CANYON VALLEY ±909 ACRE TRACT
P.O.A.D.P.

POADP # 427 - B

P.O.A.D.P REVIEW

Canyon Springs

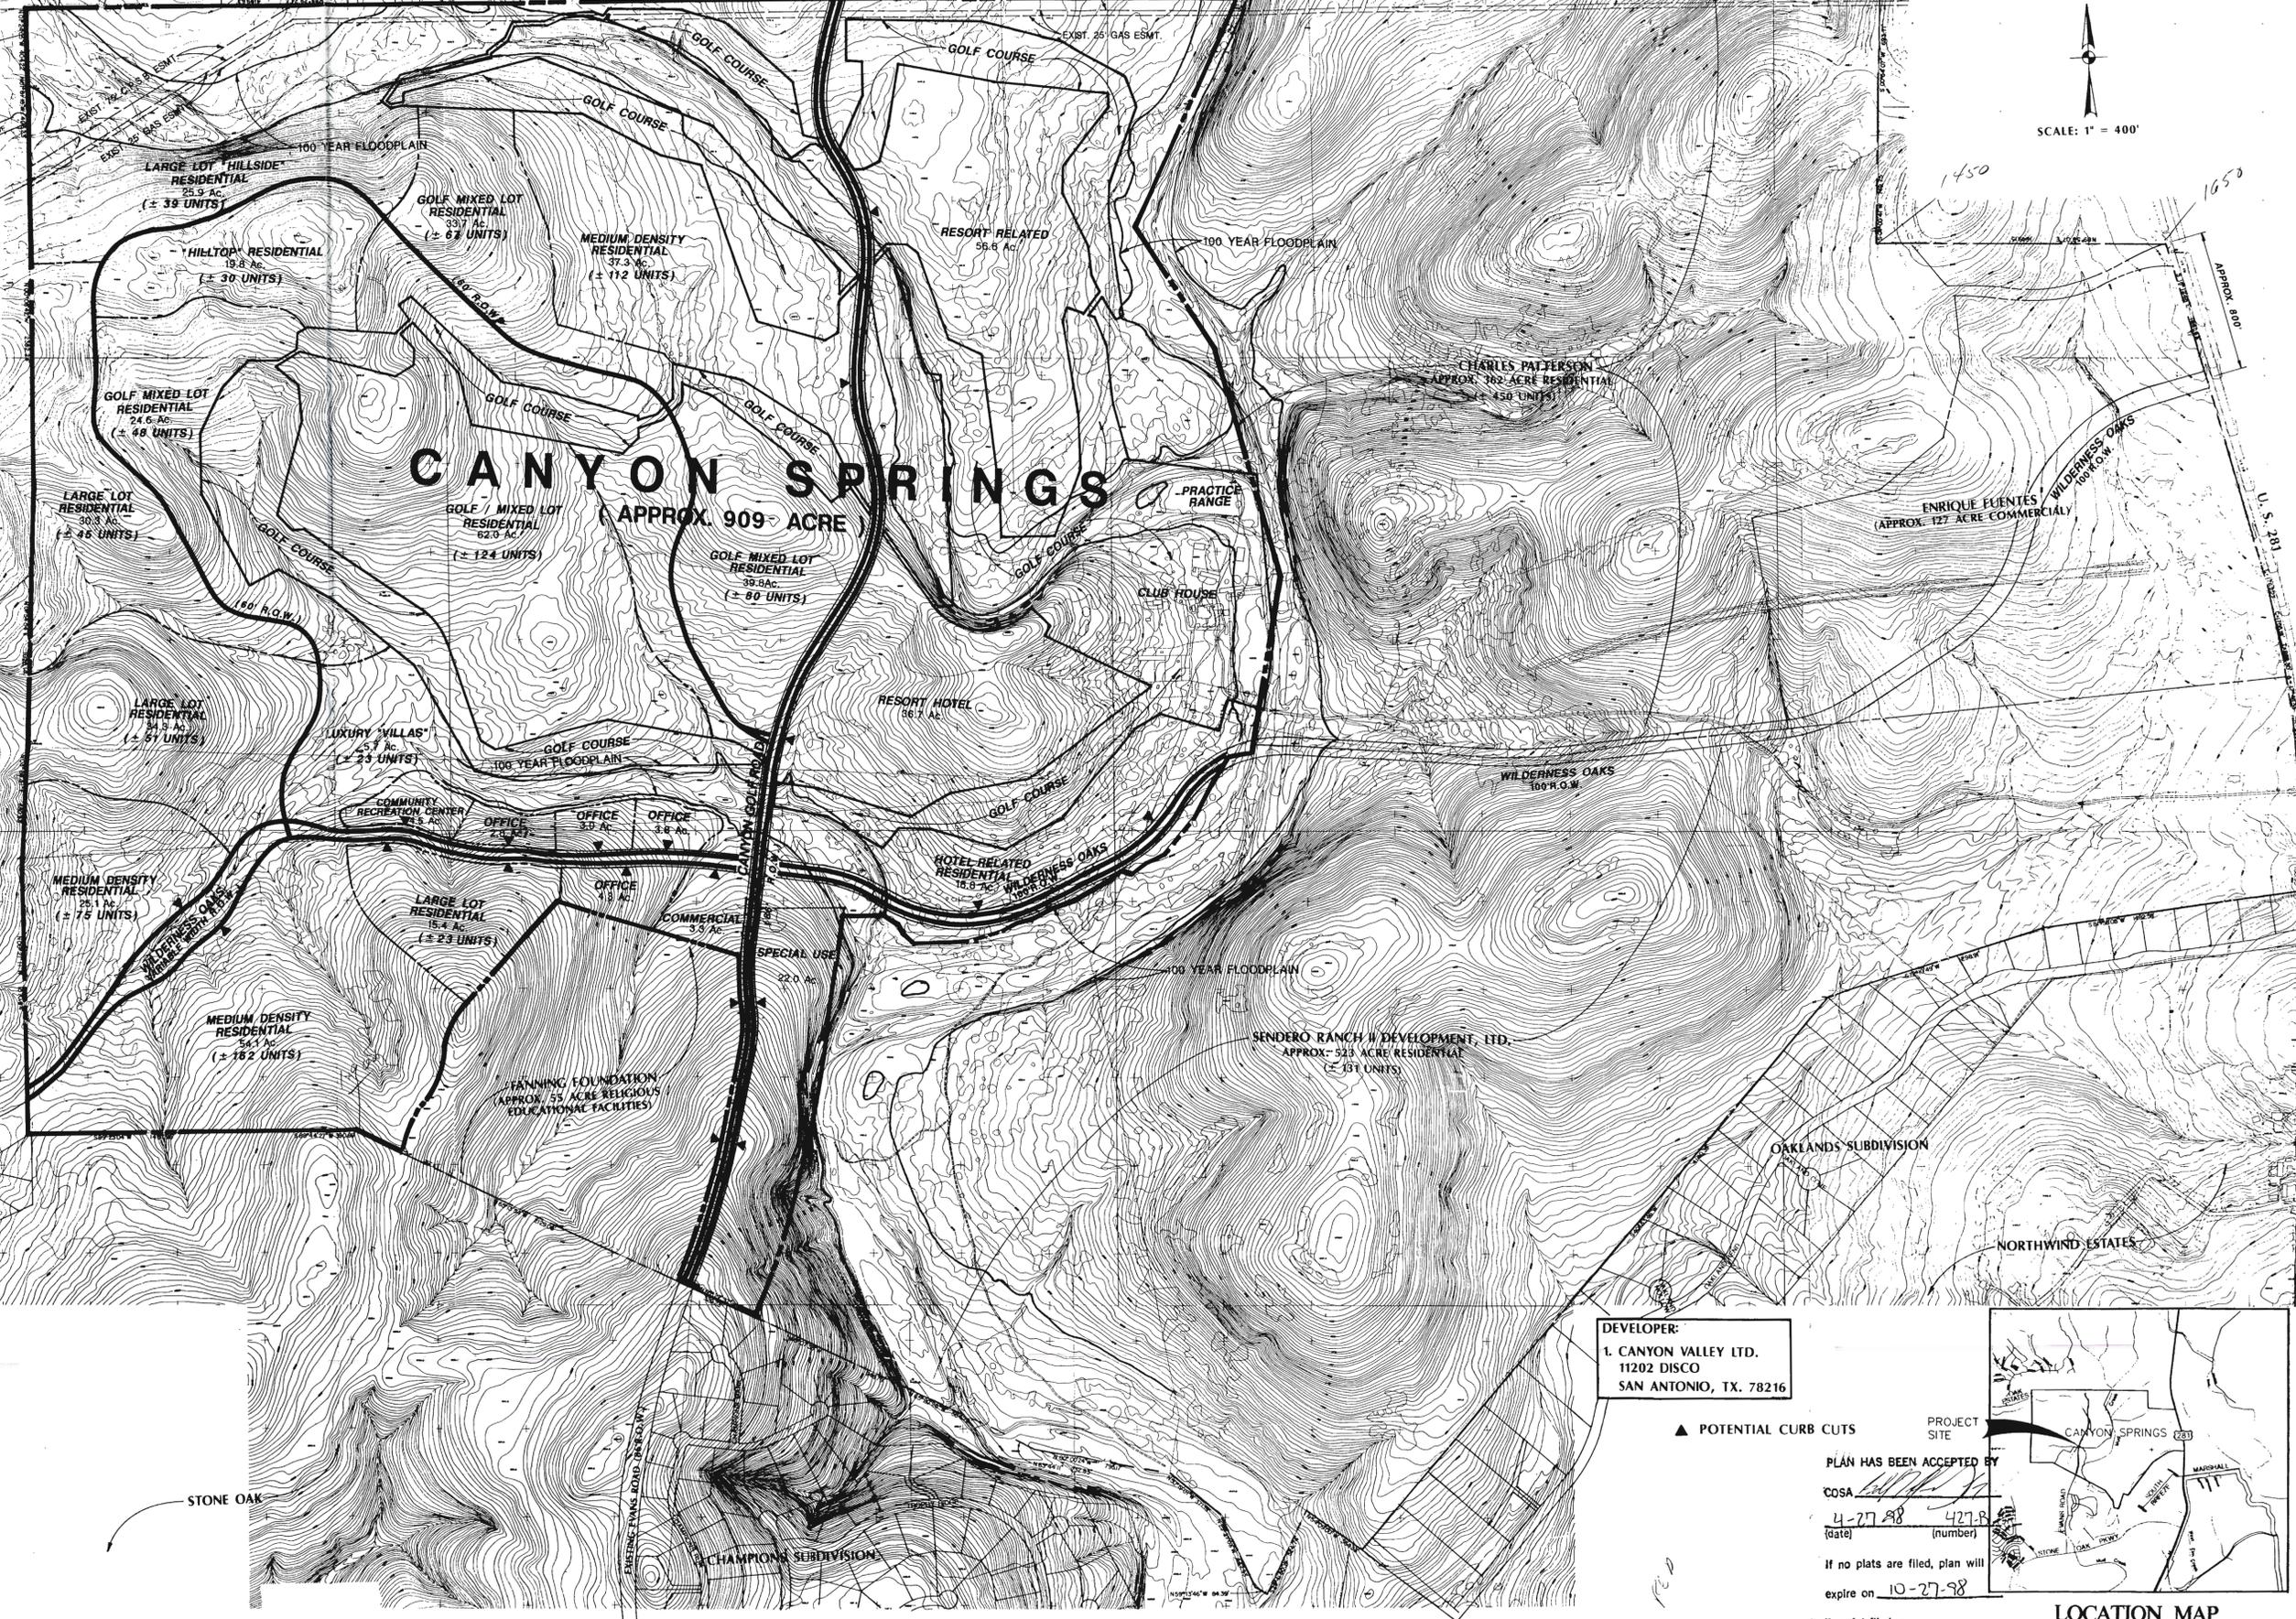
- Based on the topography, a Flood Plain Study and drainage review will probably be required during the platting process.
- In consideration of public safety and convenience, excessive grades by reason of topography should be avoided in street layouts and arrangements.

- This development will probably need to conform to requirements associated with development over the Edwards Aquifer. For additional information about these requirements you can contact SAWS at 704-7305.

- Access and R.O.W. issues along State facilities will need to be resolved with the Texas Department of Transportation (TXDOT). For additional information about these requirements you can contact TXDOT at 615-5814.

- This development will need to comply with tree preservation ordinance #85262. For additional information about these requirements you can contact Building Inspections at 207-7102.

- Staff recommends that there be no residential frontage on all collector streets.
- The alignment for Wilderness Oaks needs to be coordinated with the adjacent land owners.

- It will be expected that you will plat all of the property depicted in your POADP, to include: floodpains, drainage areas and open space.
- Staff recommend street name change for proposed north - south thoroughfare to Evans Road.
- I would like to encourage you to work closely with the school district, so that they can plan accordingly.

For residential development directly adjacent to State ROW, the developer shall be responsible for adequate set-back and/or sound abatement.

Future expansion of US 281 will require a minimum of 100 feet of additional ROW at this location. Therefore we request that all planned development be setback a minimum distance of 125 feet. 50' ROW flares will be required at the intersection of Wilderness Oaks and US 281.

Locations of access points to US 281 from this property will be as directed by "Regulations For Access Driveways to State Highways". At the time of platting, a 1' non-access easement will be required along the entire US 281 frontage of the proposed residential development. See additional comments below.

A complete copy of the approved WPAP will be required at the time of platting. State right of way will not be utilized for the purposes of treating storm water runoff from adjacent property.

ADDITIONAL COMMENTS: There are two existing temporary median crossovers on US 281 within the boundaries of this development. No additional median crossovers will be permitted within these limits, and the existing median crossovers will not be relocated. Future expansion plans for US 281 will include grade separations at Marshall Road, the future Wilderness Oak extension and Bulverde Road. The Texas Department of Transportation will not construct a grade separation at the Wilderness Oak extension that is not consistent with the location provided to TxDOT by the City of San Antonio Planning Department. The location provided is approximately 5200 feet north of Marshall Road. Please refer to the attached letter dated July 18, 1997 for further explanation of TxDOT's position of the alignment of Wilderness Oak. At the time the planned grade separations are constructed, all temporary median crossovers will be removed
